Informal Document No. GRE-64-49
(64th GRE, 4-7 October 2010,
agenda item 9)

Supplement to the proposal for 04 series of amendments to Regulation No. 10

Submitted by the expert from France

Regulation No. 10

Figure 4

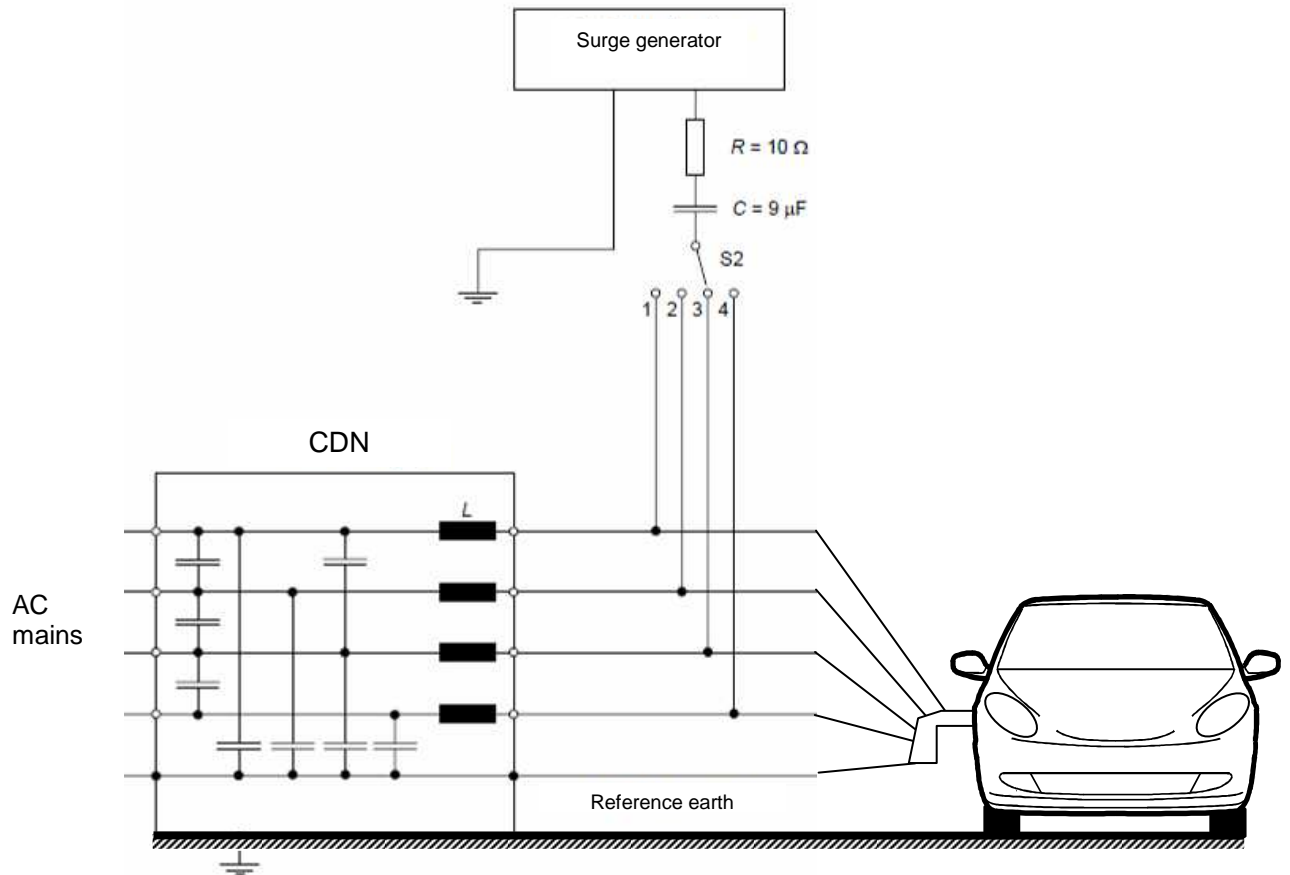
Vehicle in configuration “RESS charging mode coupled to the power grid” - Coupling between each line and earth for AC (three phases) power lines
